Certificate of Appropriateness Application

BAR 20-09-05

1619 University Avenue, TMP 090102000

Bank of America exterior lighting

SEC-EDG-2S-WM-02-E-UL-BZ-350-30K

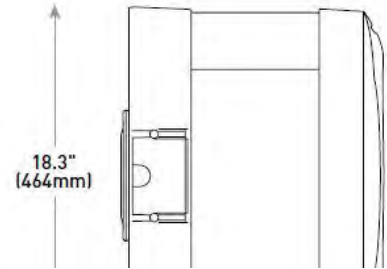
Application indicates the light fixtures will have lamping with a Color Temperature (CT) that does not exceed 3,000K; however, the fixture cut sheets indicate that none of the fixtures are available with 3,000K lamping. (See attached.)

Comment 2. I have reviewed the cut sheets provided for the new lighting fixtures and all have lamping that exceeds a Color Temperature of 4,000K, which exceeds the 3,000K maximum that the BAR will require. Also, the City Code requires that all exterior fixtures be full cut off, which is not stated in the specs for the proposed fixtures. To address bright lights and unwanted glare within the City's ADC Districts, the BAR can impose limitations on lighting levels. From this, the BAR has established a standard requiring that the light emitted from a lamp be dimmable and not exceed a Color Temperature of 3,000K.

With presentation prior to the BAR meeting of up-to-date catalog specs/cut sheets for each fixture indicating that the lamping meets the BAR’s criteria (a Color Temperature not to exceed 3,000K), staff will recommend approval.

Response: Lighting fixtures have been updated to 3,000k Color Temperature. Fixtures included are LED emitting that do not project upwards into the sky and prevent glare.

1 PHOTOMETRIC PLAN
E04.01 1" = 10'-0"

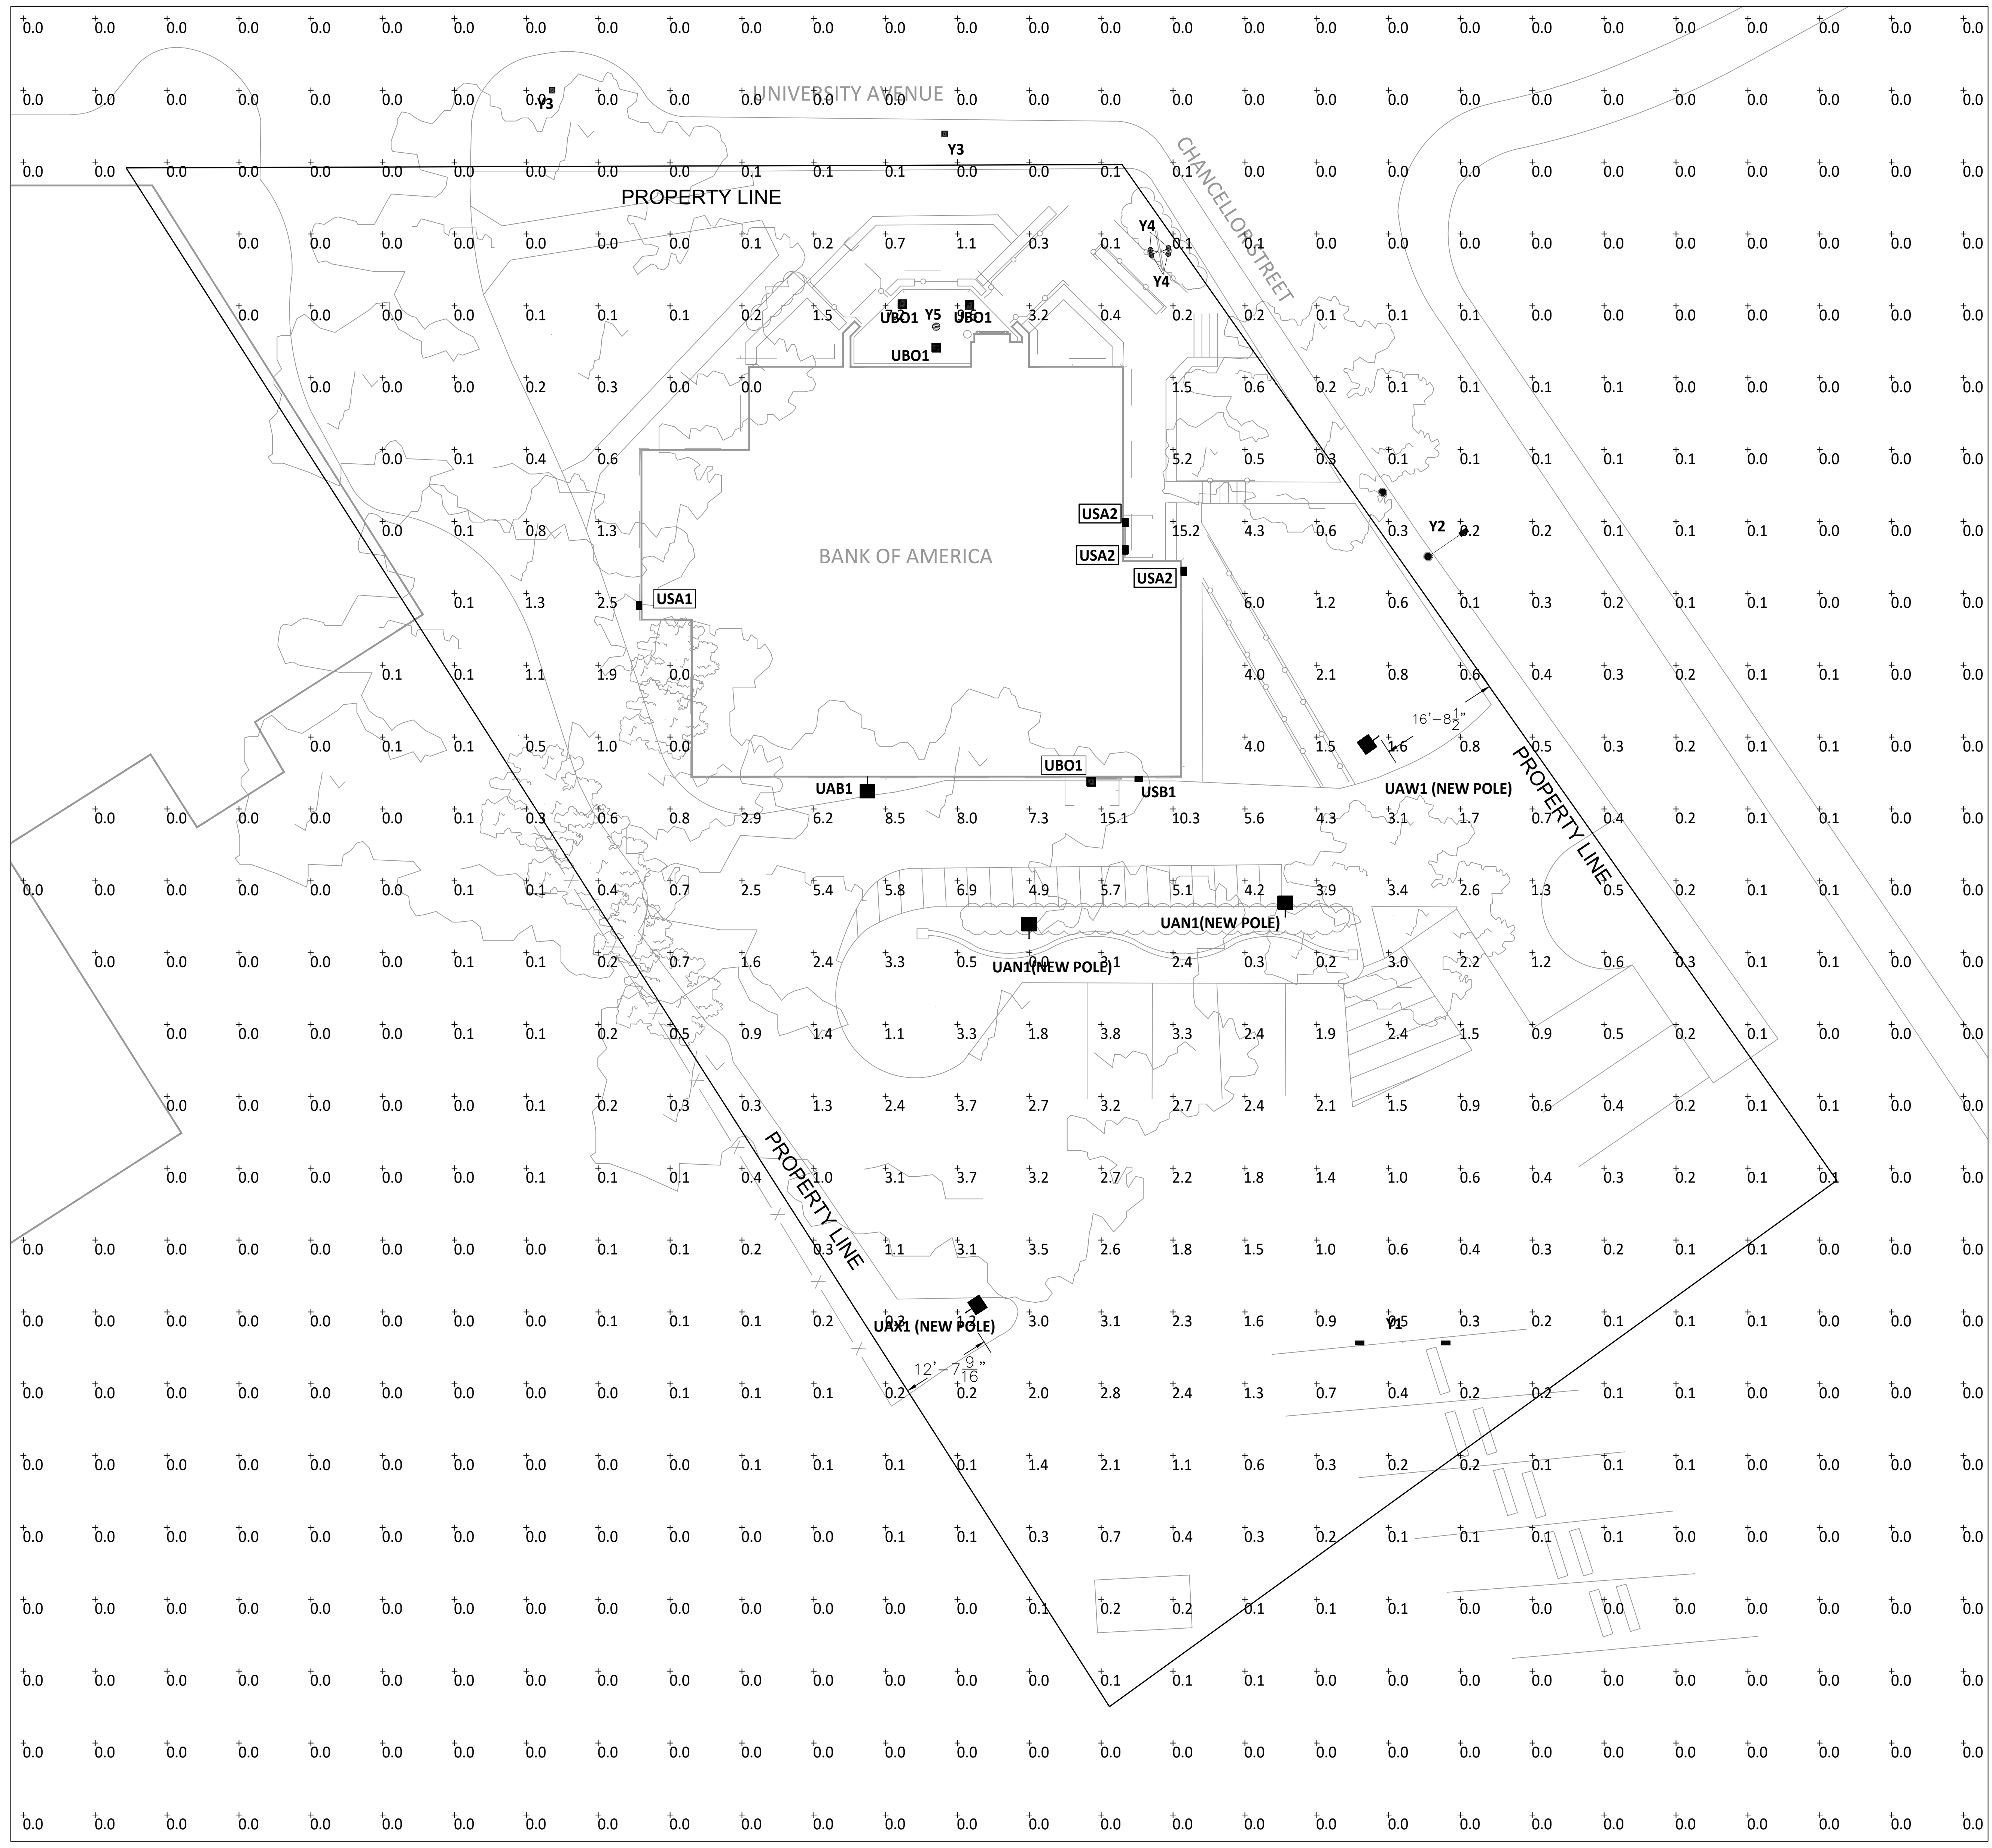
Comment 1. As per City Code Sec. 34-1003(d), the spillover light from luminaires onto public roads and onto property within any low-density residential district shall not exceed one-half (½) foot candle. There is too much spillover in areas along the northern and eastern borders of the property

Response: Lighting plan has been updated along the northern and eastern borders of the property to prevent a spillover greater than one-half foot-candle.
